# Amendment Notice 4

**Licence Number** L8308/2008/2

**Premises** Sino Iron Project Mine Site  
Mining Tenements M08/123, M08/124, M08/125,  
M08/264, M08/265, M08/266, G08/54 and L08/126  
MARDIE WA 6714

**Date of Amendment** 12/01/2018

**Figure 1: Pipeline route and diffuser location**

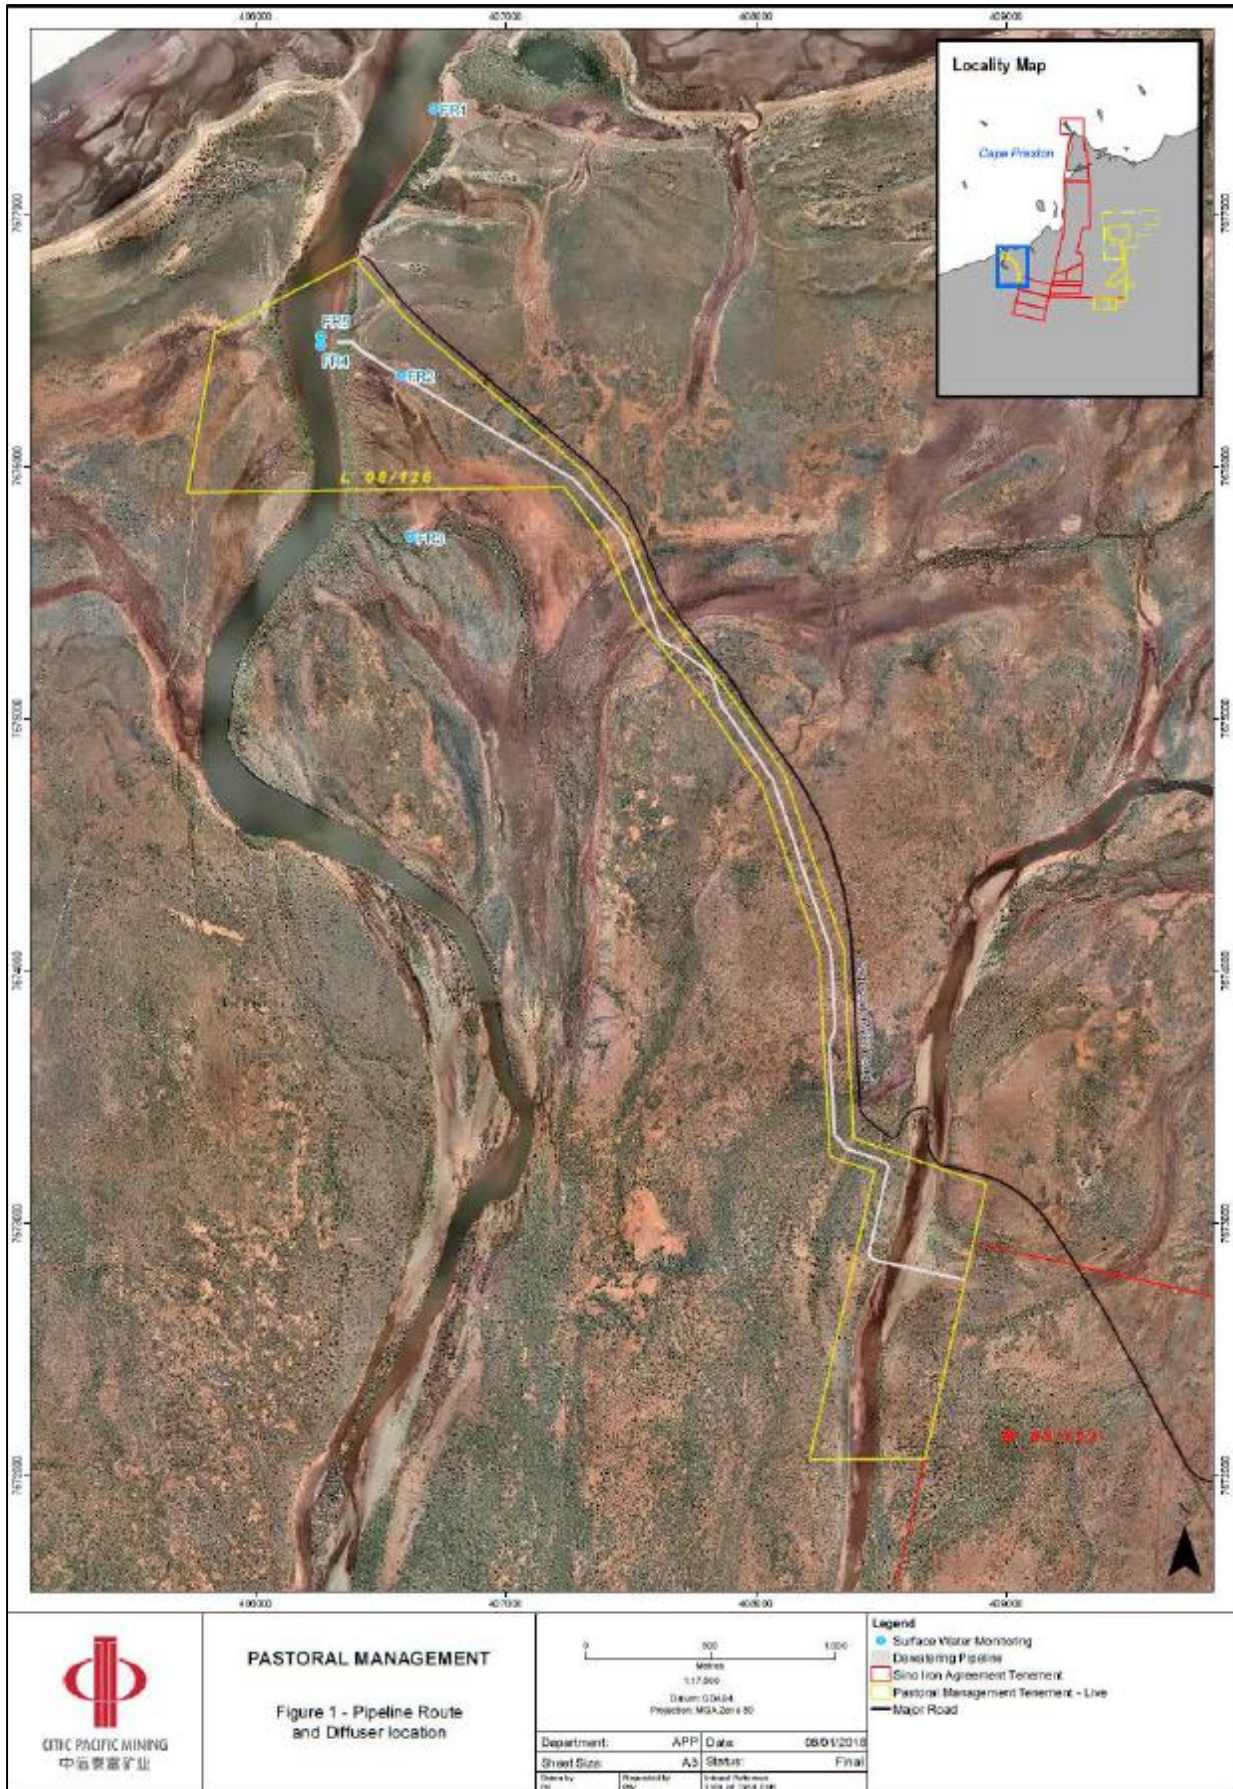
The Existing Licence currently authorises the Licensee to discharge up to 2 GL/a of excess mine dewater to the Fortescue River via a diffuser (FR2 as shown in Figure 1). The increased discharge will be via a similar diffuser system and improvements to the discharge infrastructure will be staged to align with the dewatering requirements as shown in Table 3.

Condition	Summary of Licence Holder comment	DWER response
Figure 1	Figure 1 updated to reflect the final diffuser location as detailed within CPM, February 2017	Figure 1 has been updated
Table 3	Under key infrastructure for the 6 GL/a discharge rate it should read “63 m (offset approximately 25 m from the low water mark)” rather than “46 m (offset approximately 25 m from the low water mark)”	Table 3 has been updated to state 63 m for the discharge rate of 6 GL/a
Attachment 1	Attachment 1 updated to omit emission point AP1 which is outside the scope of this Amendment Notice and FR2 updated to reflect final diffuser location as detailed within CPM, February 2017	Attachment 1 has been updated with the two Maps of emissions and monitoring points

## Map of emissions and monitoring points

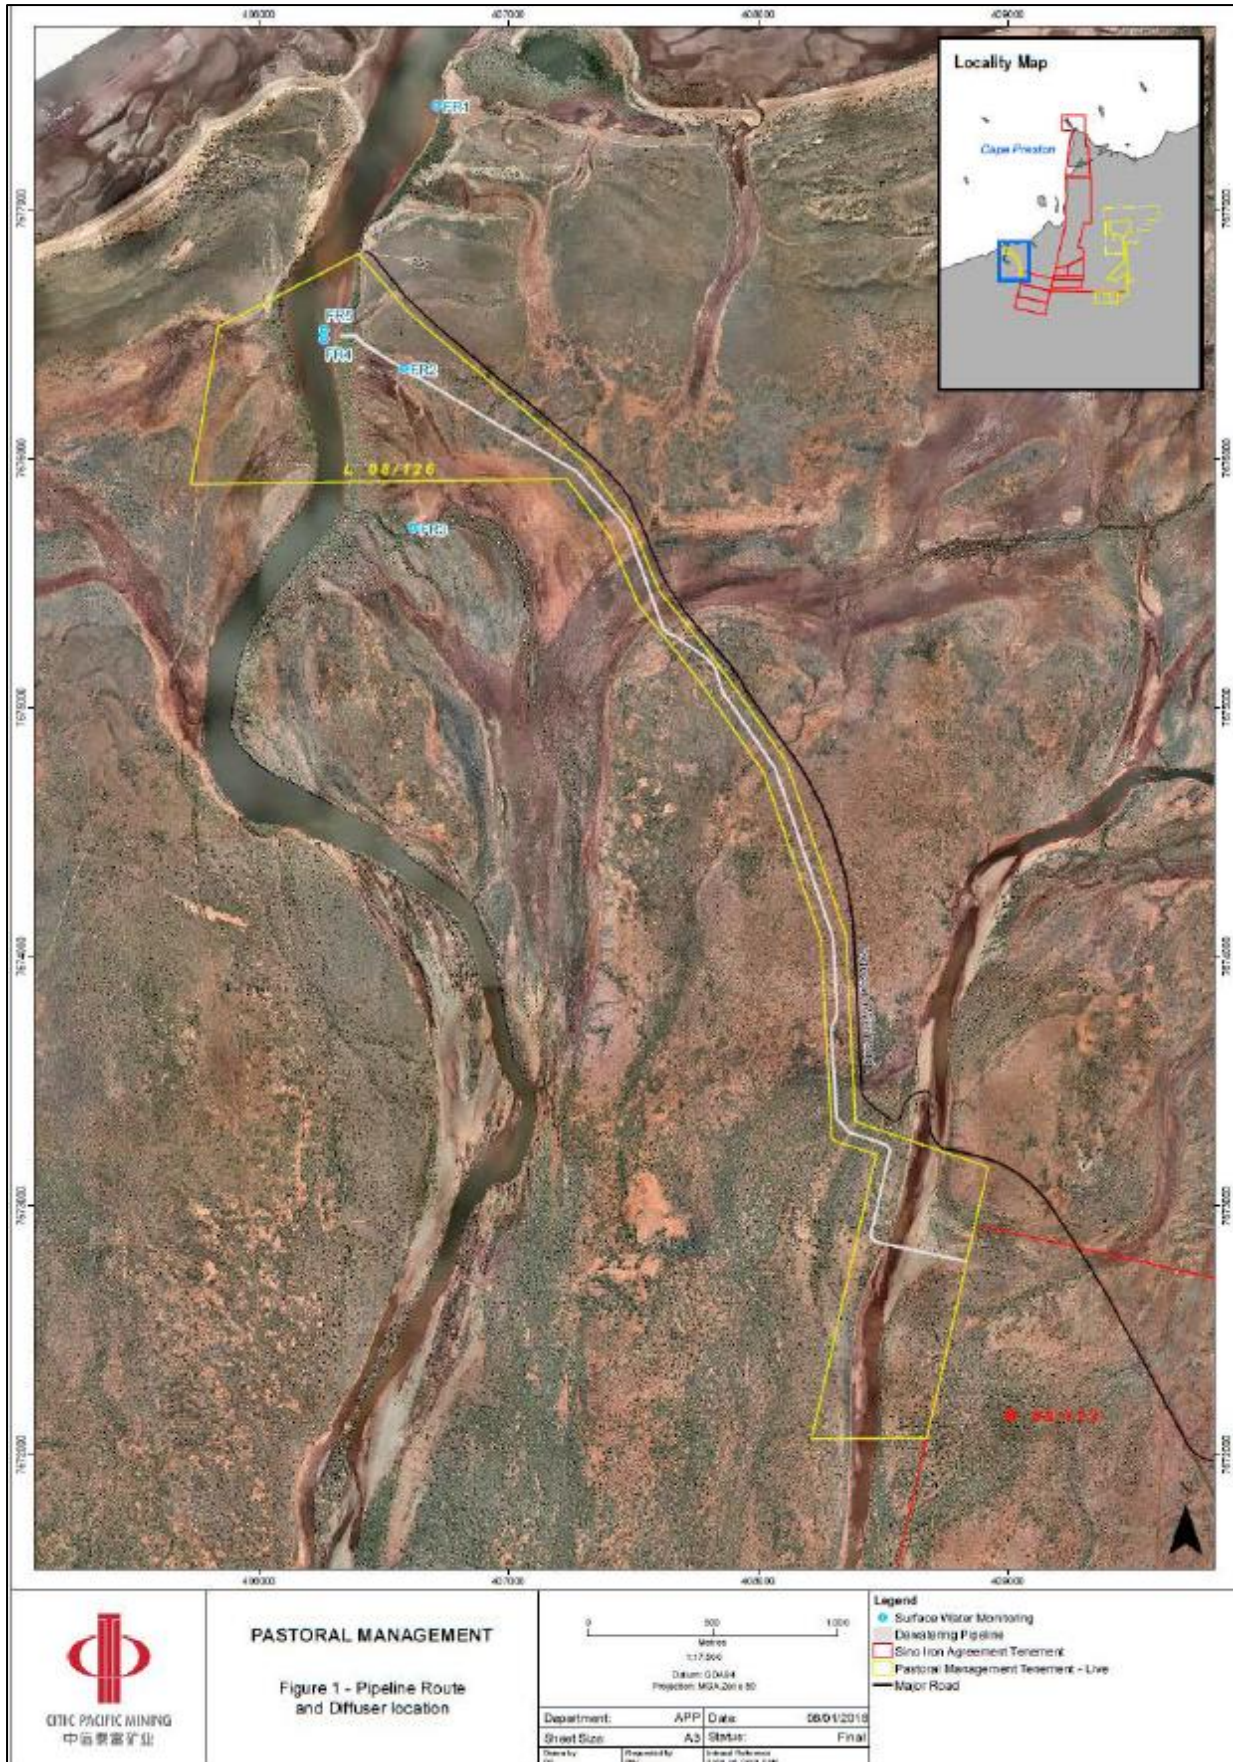
- The two maps of emissions and monitoring points have also been updated via this Amendment Notice.
- Form WR1 for monitoring of point source emissions to surface water has been updated via this Amendment Notice to include updates from the Existing Licence.

10. The Maps of emissions and monitoring points in Schedule 1 has been deleted and replaced with the maps in Attachment 1 of this Amendment Notice.
11. The WR1 Form in Schedule 2 is deleted and replaced with the form in Attachment 2 of this Amendment Notice.
